Interstate 580/Patterson Pass Road/International Parkway Diverging Diamond Interchange Improvements Project, CIP 73147, Federal Project Number: ACSB1IM-580-1(982)E

Subject: Addendum No. 4

ADDENDUM NO. 4

RETAINING WALL PLAN RW No. 4, TYPICAL SECTION

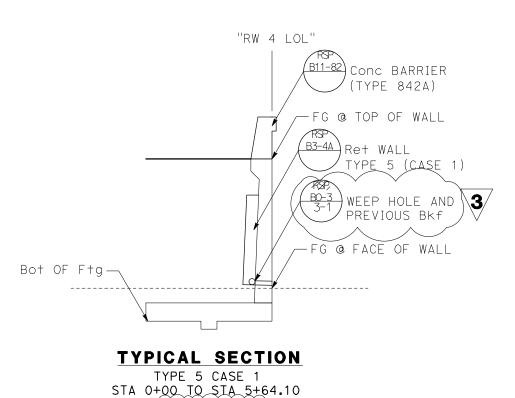
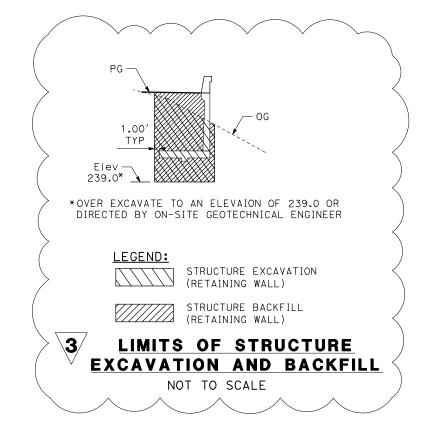
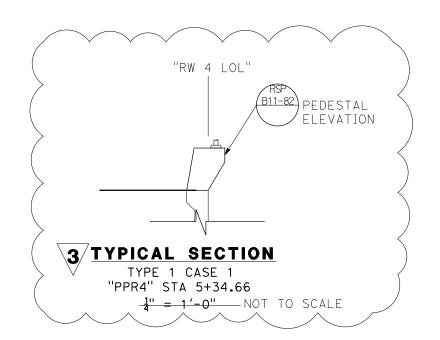
- A4.13 Follow General Conditions Part 3.3 and any instructions issued in bid addendums applicable to this section.
- Q4.14 Plan Sheet R-8 (Retaining Wall Quantities) shows Wall #4 as being 153 LF long. Plan Sheet R-6 shows Wall #4 as being 564 LF in length. Can you please verify and adjust quantities for bid item numbers 40, 41, 64, 69 and 123.

- A4.47 Type 1
- Q4.48 Seems to be a discrepancy on the length of R.W No. 4 as well. Please verify if the length should be 153' or 564'? Please adjust the quantity accordingly as well.

- A4.14 Retaining wall sheets revised and Bid Schedule revised (See Attachment A).
- Q4.15 Please clarify any material requirements pertaining to Bid Item Number 90 for Gravel Filters. This item is depicted by the Drainage Details Plan Sheets DD-5 and DD-6, but the required material composition is not identified by the City or Caltrans Specifications.

- A4.48 Retaining wall sheets revised and Bid Schedule revised (See Attachment A).
- Q4.49 Bid Item 158. Quantity seems way low. What is included in this item? Please verify that the EE quantity of 308 LB is correct.
